<b>Device</b>	<b>XC161CJ-16F</b>
<b>Marking/Step</b>	<b>(E)ES-BB, BB</b>
<b>Package</b>	<b>PG-TQFP-144-7, P-TQFP-144-19</b>

This Errata Sheet describes the deviations from the current user documentation.

**Figure 1 Example for Case 2: Interrupt Service for Task C delayed**

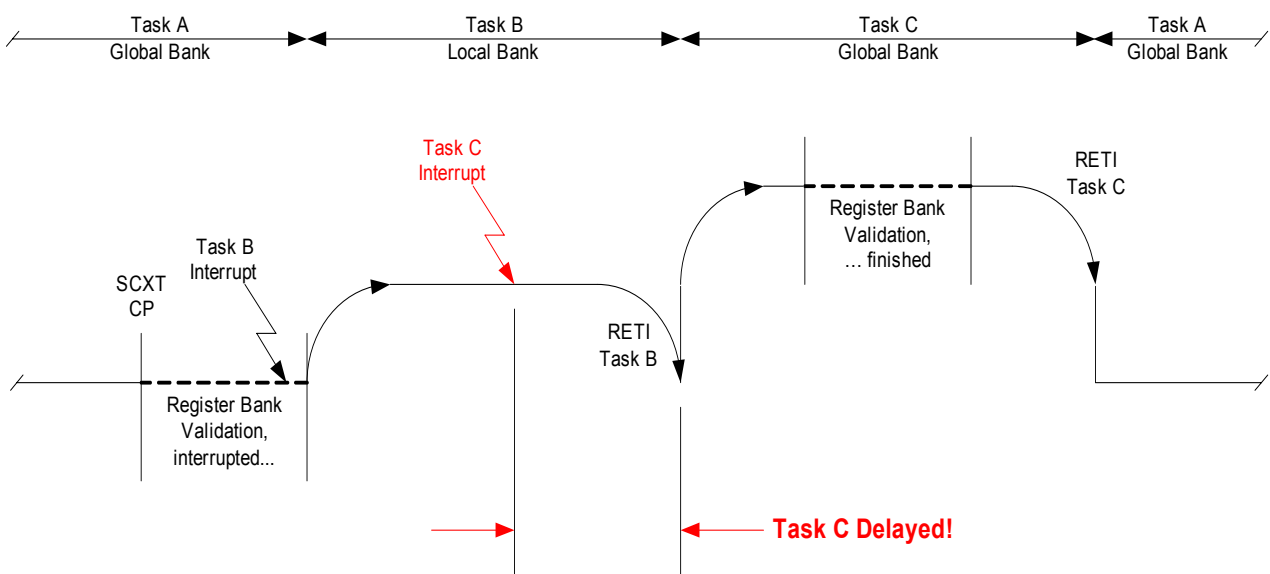
Case 2 (see also Figure 1):

- The Context Pointer CP is written to (e.g. by POP, MOV, SCXT .. instructions) within a routine (Task A) that uses a **global** register bank (bit field PSW.BANK = 00<sub>B</sub>), i.e. the context for this routine will be modified,
- This context switch procedure (19 cycles) is interrupted by an interrupt request (Task B) which is programmed (with GPRSELx = 1X<sub>B</sub>) to automatically use one of the **local** banks via the bank selection registers BNKSEL0..3 (i.e. the interrupting routine has a priority level ≥12),
- Before the corresponding interrupt service routine is finished, another interrupt request (Task C) occurs which is programmed (with GPRSELx = 00<sub>B</sub>) to automatically use the **global** bank via the bank selection registers BNKSEL0..3 (i.e. the interrupting routine has a priority level ≥13)

In this case service of this interrupt request (for Task C) is delayed until bit field PSW.BANK becomes 00<sub>B</sub> after executing the RETI instruction at the end of the routine (Task B) using the local bank.

### Workaround for Case 2

When using both local and global register banks via the bank selection registers BNKSEL0..3 for interrupts on levels ≥12, ensure that there is no interrupt using a global register bank that has a higher priority than an interrupt using a local register bank.
